Access Compliance Report

Public Rights-of-Way

(Curb Ramps)

Intersection ID: 13709	Main Street: SHENANDOAH_AV	Cross Street: ST_JULIEN_ST	Location: W
ADA ID: 26708100A250	Ramp Type: PerpDiag	Initial Pass/Fail: Fail	Overall Compliance: No
Severity Score: 8.75			
Codes/Mitigation Info/Possible Solution		Field Measurements/Component Compliance

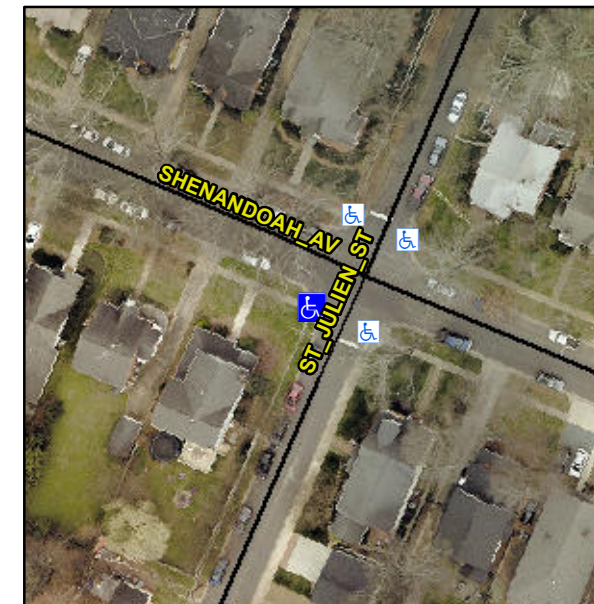
Not Found, R304.5.1

Compliance	Description	Data	Compliance	Description	Data
N/A	Ramp Length (in)	43.0	Yes	Ramp Slope (%)	7.8
No	Ramp Width (in)	47.0	Yes	Ramp XSlope (%)	1.2
N/A	Flare Type LT	N/A	N/A	Flare Type RT	N/A
N/A	Flare Slope LT (%)	N/A	N/A	Flare Slope RT (%)	N/A
N/A	Flare Traversable LT?	N/A	N/A	Flare Traversable RT?	N/A
N/A	Landing Length (in)	N/A	N/A	DWS Provided?	N/A
N/A	Landing Width (in)	N/A	N/A	DWS Contrast?	N/A
N/A	Landing Slope (%)	N/A	N/A	DWS Length (in)	N/A
N/A	Landing X Slope (%)	N/A	N/A	DWS Full Width?	N/A
N/A	Landing Curb? (Y/N)	N/A	N/A	DWS Offset (in)	N/A
N/A	Shared Landing?	N/A			
N/A	Gutter Ponding?	N/A	N/A	Gutter Slope (%)	N/A
N/A	Gutter Lip Ht (in)	1.5	N/A	Gutter X Slope (%)	N/A
N/A	Painted X Walk1?	No	N/A	Painted X Walk2?	No
	X Walk 1 Direction	To SE		X Walk 2 Direction	To NE
N/A	X Walk 1 Width (in)	N/A	N/A	X Walk 2 Width (in)	N/A
	X Walk 1 Slope (%)	8.7		X Walk 2 Slope (%)	5.2
	X Walk 1 X Slope (%)	4.4		X Walk 2 X Slope (%)	2.8

Remove & Replace Curb Ramp With Two New Directional Ramps or Equivalent.
